Re: AUDIT OF REVISED BASEMENT IMPACT ASSESSMENT FOR 168 HAVERSTOCK HILL, LONDON NW3 2AT (2014/6736/P)

Further to your instruction, we have now completed our audit of the revised Basement Impact Assessment (BIA) relating to the proposed basement construction at the above site and this letter forms our report on the review.

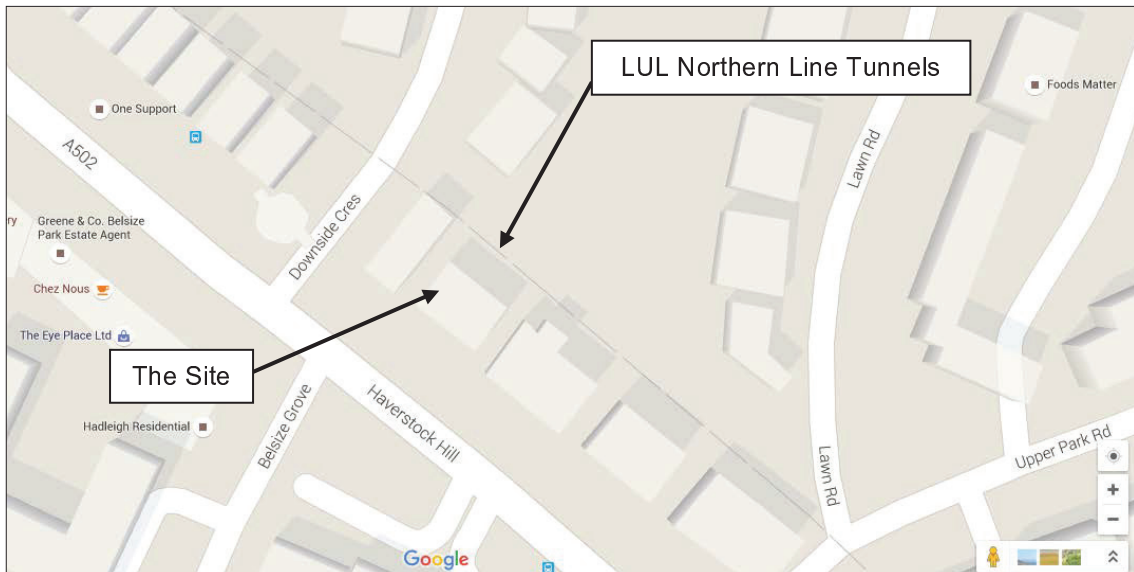
to inform this BIA. Question No 13 refers to significant increases in the differential depth relative to adjacent properties. We concur with the response to this question but there is insufficient detail to assess the impact at this stage. Question No 14 refers to the proximity of tunnels to the development. The previous BIA made reference to the Northern Line tunnels which appear lie at depth in beneath the rear of the site as shown on the extract from Google maps below.

The Soiltechnics BIA, however, indicates that there are no tunnels within 50 m of the site. It is considered that this is an incorrect statement and now that the scheme has a bored pile wall probably directly over the tunnels then contact with London Underground Limited should take place and their requirements should be confirmed and incorporated into the BIA. The Belsize Park Deep Level Air-Raid Shelter is also noted to be present in the vicinity of the site although it is understood that the shelter lies to the northwest of the Northern Line tunnels and at a depth that is unlikely to be significantly affected by the proposed basement.
